80/81 PCS State Machines for EEE

IEEE 802.3bp - Interim Meeting - January 2015

Brett McClellan, Marvell

▶ **80/81 TX State Machine**

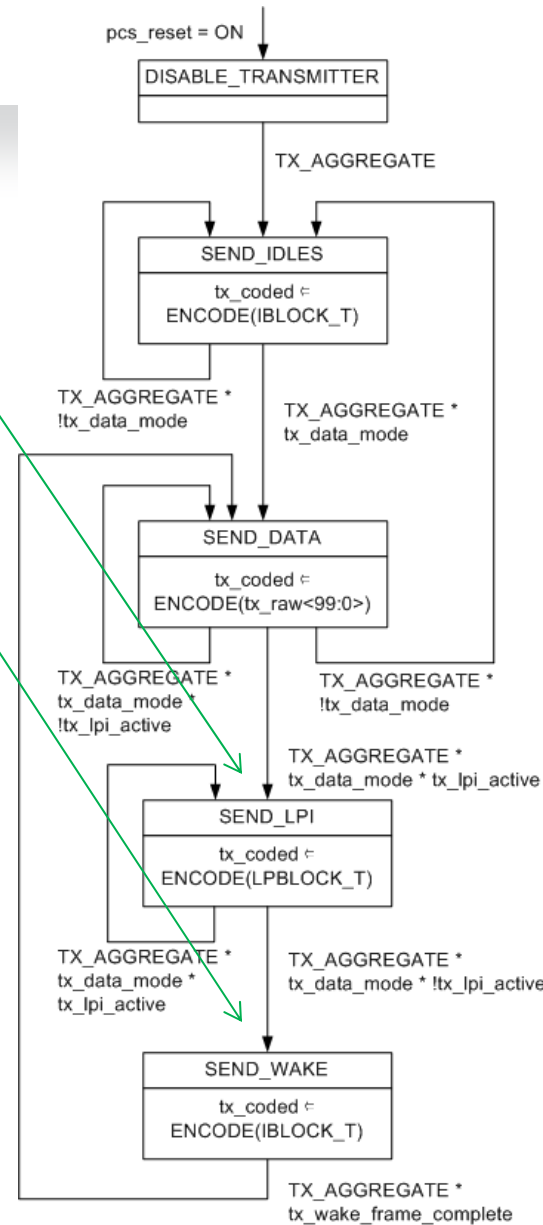
- Encode constant LP_IDLE starting on RS frame alignment until exit from LPI.

- Send constant LP_IDLE to GMII until exit from LPI.

PCS Receive State Diagram

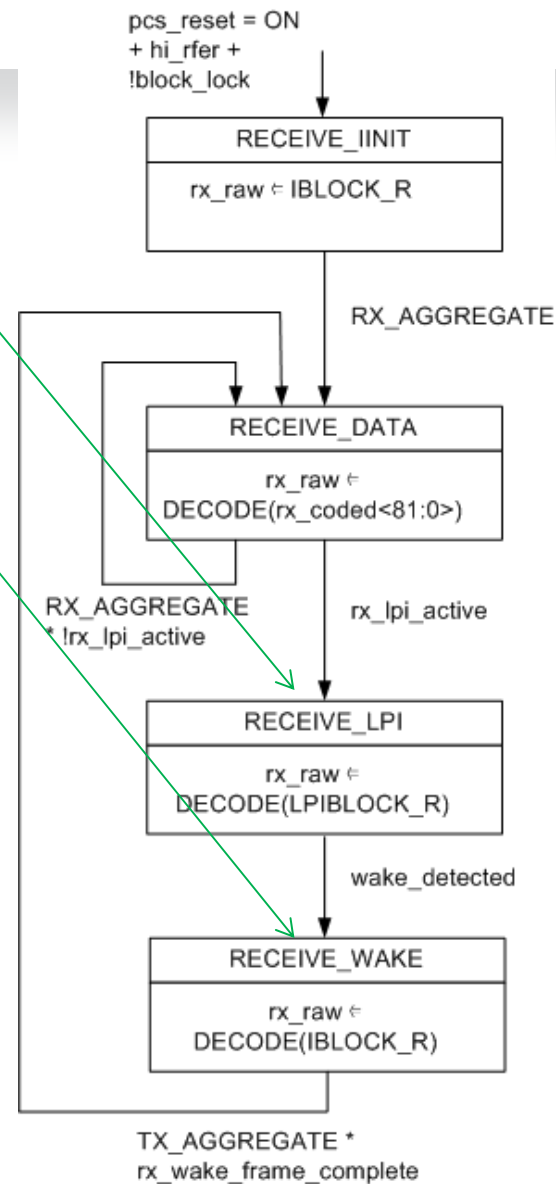
- ▶ Send constant LP_IDLE to GMII until exit from LPI.
- ▶ Upon wake detection send constant IDLE to GMII until end of WAKE RS frame.
- ▶ rx_lpi_active set TRUE upon detection of LP_IDLE. Set FALSE upon wake_detection.
- ▶ wake_detected set TRUE upon detection of the WAKE RS frame.
- ▶ rx_wake_frame_complete set TRUE at end of WAKE RS frame, otherwise FALSE

RFER Monitor State Diagram

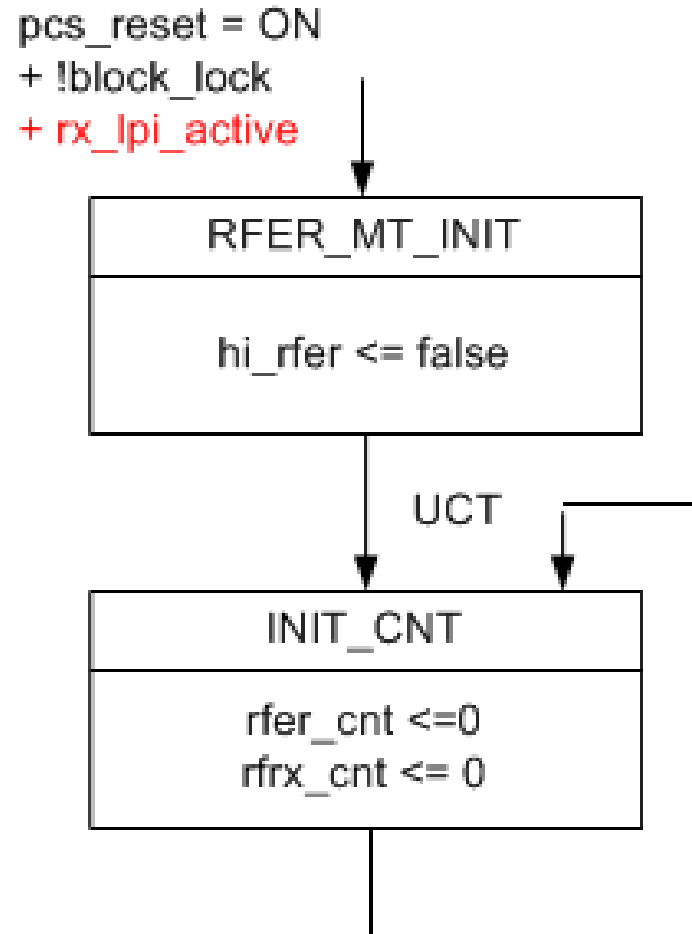
- ▶ **Issue:**
 - Suspend monitor during low power idle
- ▶ **Resolution:**
 - Hold state machine in RFER_MT_INIT during LPI
